Report to Planning Committee

Application Reference	DC/23/68367
Application Received	20 June 2023
Application Description	Proposed two storey side and single storey front/side/rear extensions.
Application Address	57 Valentine Road Oldbury B68 9AH
Applicant	Mr Waqar Ahmed
Ward	Bristnall
Contact Officer	Beth Astley-Serougi Beth_AstleySerougi@sandwell.gov.uk

DRAWING NUMBER WA223 - O2C

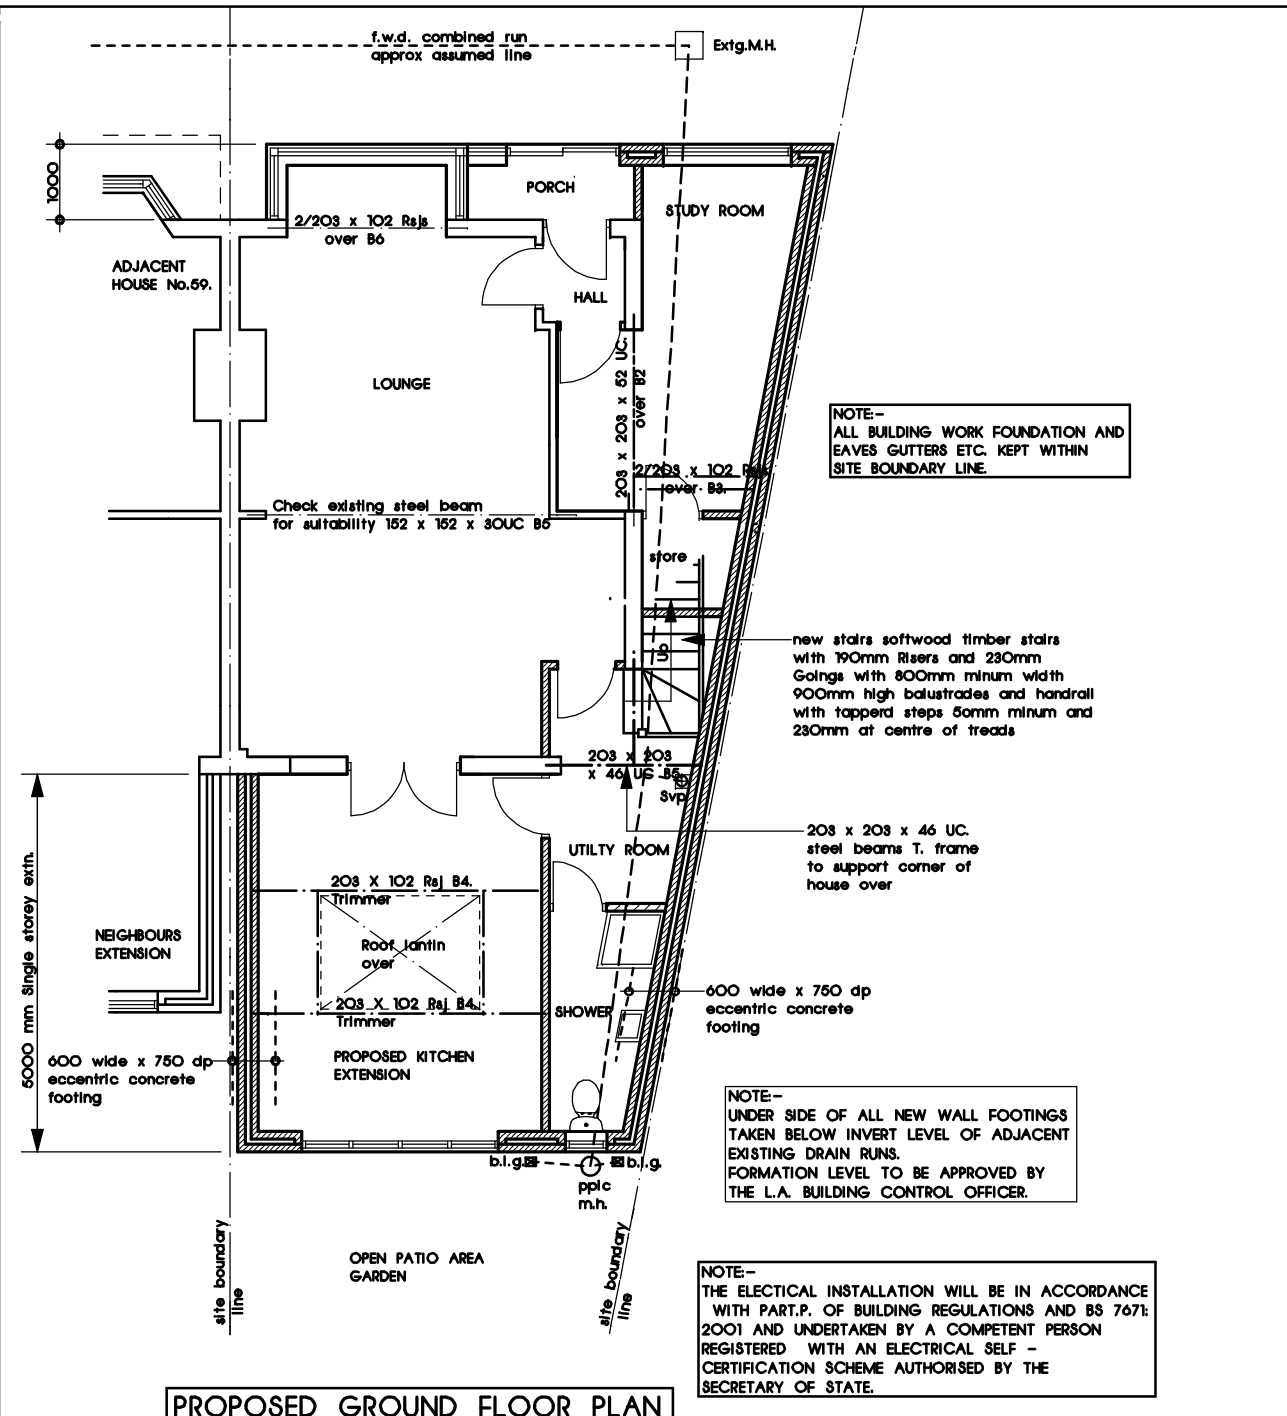
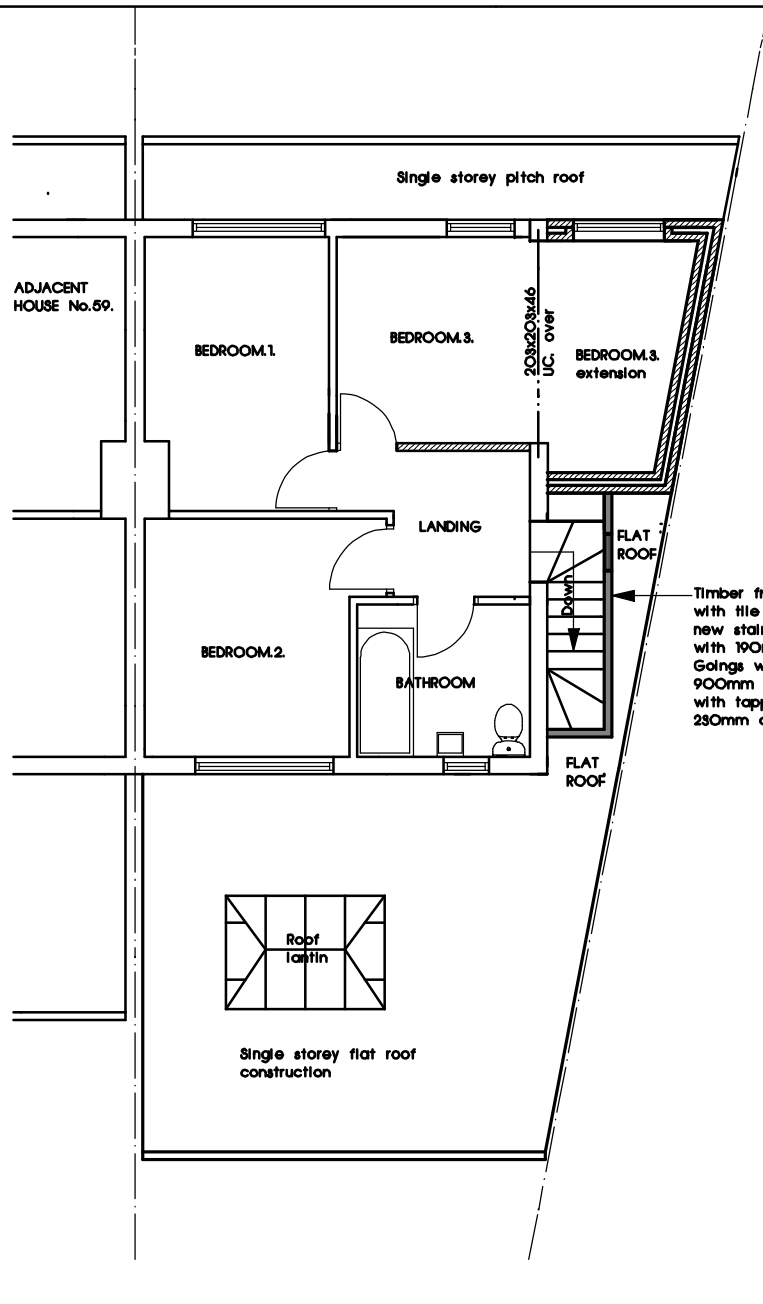
With regards to the neighbouring property to the left of the applicants property, it is considered that the floor plans demonstrate that the ground floor and first floor side extensions would not significantly impact any loss of light for habitable windows to an extent that would warrant a refusal. The single storey rear extension is comprised of a flat roof with roof lantern and therefore has been designed sympathetically to limit any possible negative impact on neighbouring properties regarding loss of light or outlook. Therefore, it is my view that the ground floor side and rear extensions would not result in any significant loss of light to the adjoining semi-detached property nor other adjacent properties.

There is one window on the side elevation of the proposed first floor development and one toilet window on the ground floor rear extension both of which are recommended to be conditioned to be obscurely glazed and retained as such. It is therefore considered the privacy of the adjacent properties will be maintained.

The first-floor side extension is sympathetic to any possible impact upon neighbouring properties and does not project further than the existing rear elevation of the property. It is therefore considered that there will not be a significant impact upon loss of outlook or light for neighbouring properties.

Amended plans have been received in which the applicant has omitted plans for a roof extension and loft conversion. This has ensured that the amended plans would not be overly dominant, erode legibility of the street scene nor result in an imposing design upon the neighbouring properties.

- i) External Materials to match the existing property
- ii) The bathroom window on the rear elevation of the single storey rear extension is to be obscurely glazed and retained as such.
- iii) The window located on the first-floor side extensions is to be obscurely glazed and retained as such.

DRAWING NUMBER WA223 - O3C

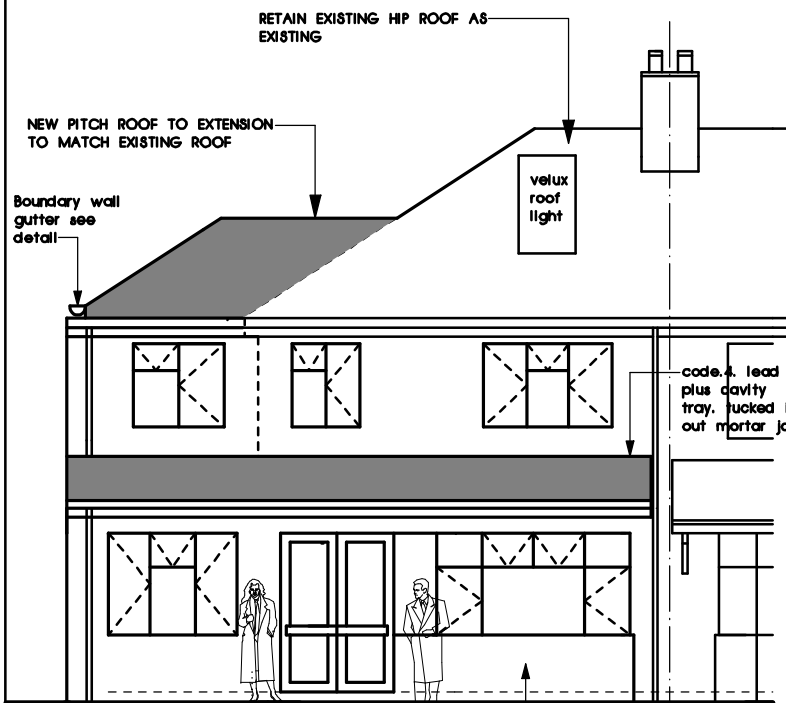
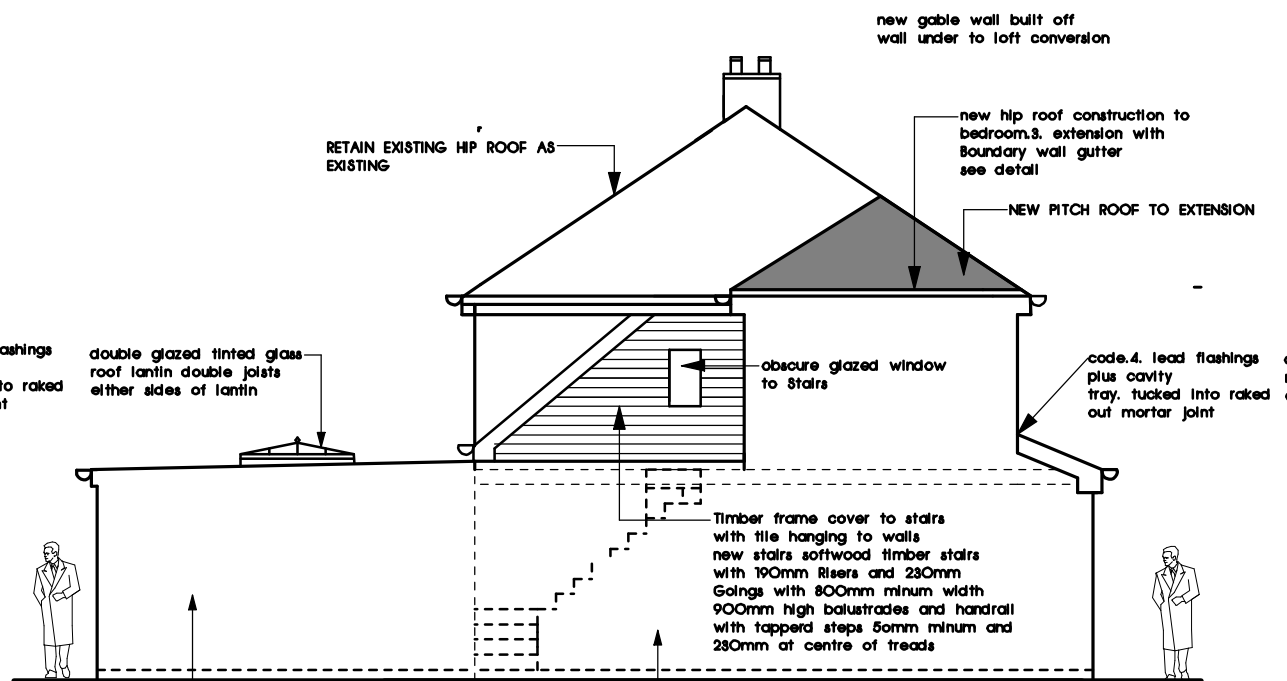
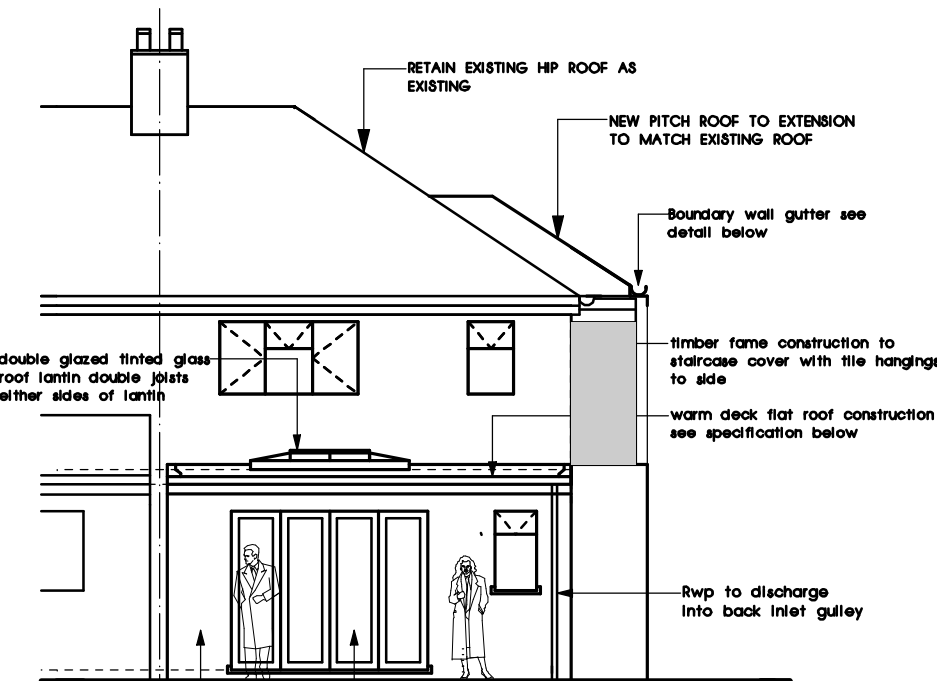
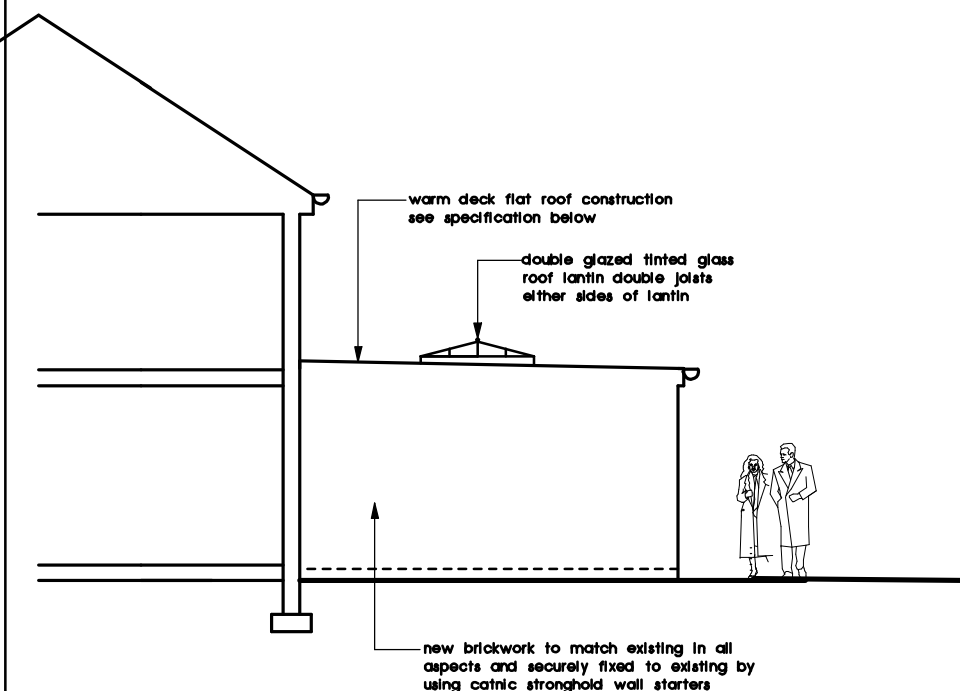
In my opinion, the design of the extensions proposed is broadly satisfactory and I do not consider this would result in any undue harm to the character of the area. The side extension has been set down from the highest point of the roof. This results in a subordinate design to the original dwelling house. Due to the orientation of the applicant's property and its' relationship with neighbouring properties I do not consider the need for the set back of the first floor to be essential in achieving a subordinate design.

The front extension I do not consider to erode the original character of the dwelling house, nor will it impact the visual amenity of the surrounding area. The window proposed will assimilate with the original character of the dwelling house.
